Access Compliance Report

Public Rights-of-Way

Intersection ID: 10024493	Main Street: CROWNPOINT_EXECUTIVE_DR	Cross Street: N/A	Location: NE
ADA ID: D1086FF54772	Ramp Type: PerpDiag	Initial Pass/Fail: Fail	Overall Compliance: No
Severity Score: 33.75			
Codes/Mitigation Info/Possible Solution		Field Measurements/Component Compliance

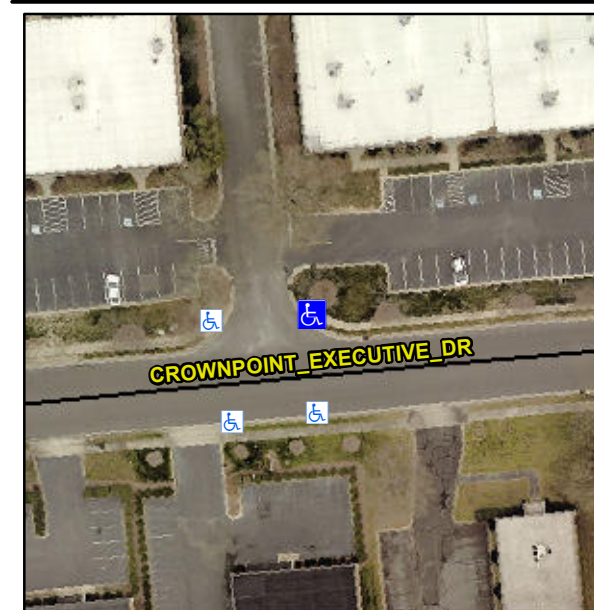
Not Found, R304.5.1, R304.5.3

Compliance	Description	Data	Compliance	Description	Data
N/A	Ramp Length (in)	86.0	Yes	Ramp Slope (%)	6.3
No	Ramp Width (in)	46.0	No	Ramp XSlope (%)	7.0
N/A	Flare Type LT	N/A	N/A	Flare Type RT	N/A
N/A	Flare Slope LT (%)	N/A	N/A	Flare Slope RT (%)	N/A
N/A	Flare Traversable LT?	N/A	N/A	Flare Traversable RT?	N/A
N/A	Landing Length (in)	N/A	N/A	DWS Provided?	N/A
N/A	Landing Width (in)	N/A	N/A	DWS Contrast?	N/A
N/A	Landing Slope (%)	N/A	N/A	DWS Length (in)	N/A
N/A	Landing X Slope (%)	N/A	N/A	DWS Full Width?	N/A
N/A	Landing Curb? (Y/N)	N/A	N/A	DWS Offset (in)	N/A
N/A	Shared Landing?	N/A			
N/A	Gutter Ponding?	N/A	N/A	Gutter Slope (%)	N/A
N/A	Gutter Lip Ht (in)	N/A	N/A	Gutter X Slope (%)	N/A
N/A	Painted X Walk1?	No	N/A	Painted X Walk2?	No
	X Walk 1 Direction	To W		X Walk 2 Direction	To S
N/A	X Walk 1 Width (in)	N/A	N/A	X Walk 2 Width (in)	N/A
	X Walk 1 Slope (%)	4.7		X Walk 2 Slope (%)	4.3
	X Walk 1 X Slope (%)	3.0		X Walk 2 X Slope (%)	4.8

Remove & Replace Curb Ramp With Two New Directional Ramps or Equivalent.
